Our Reference: OW/2023/5266
 Contact Officer: Samita Thapa
 Contact: 07 4688 8379
 Email: development@tr.qld.gov.au

FURTHER ADVICE
Planning Act 2016 Section 68
Development Assessment Rules Section 35

Application for: Operational Works - Roadwork Stormwater Water and Sewerage Infrastructure
Location: Colbar Street, PITTSWORTH QLD 4356
Property Description: Lot 101 SP257259

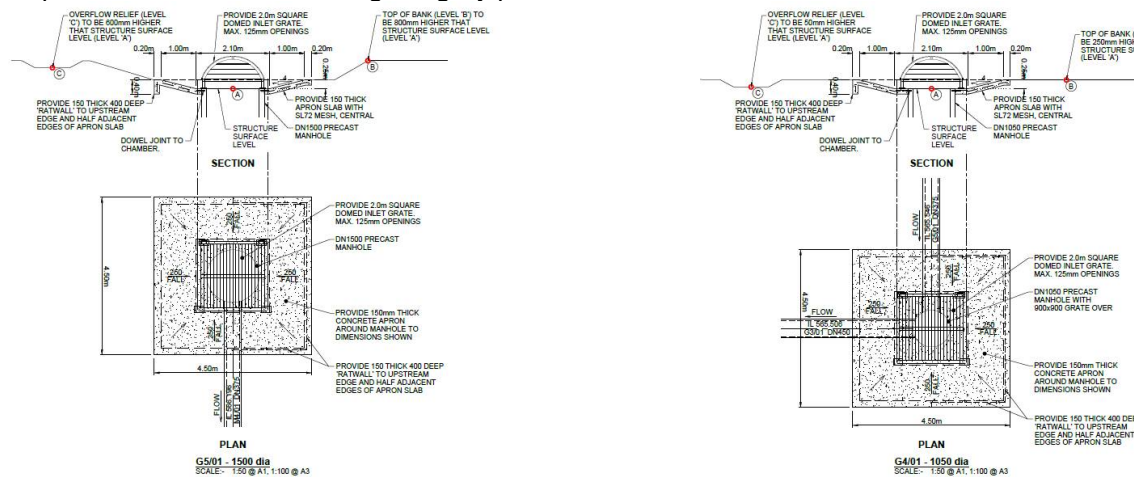
2.1	Issue: It is noted that the clearance between the proposed driveway for Lot 86 and proposed watermain is less than 1.0m.
	Information Required: Please submit an amended plan addressing the above issue.
2.2	Issue: It is to note that existing duck foot hydrant to be removed from the frontage of Lots 87, 104 and 117. The hydrant in front of Lot 87 is to be replaced by a sluice valve.
	Information Required: Please submit an amended plan addressing the above issue.
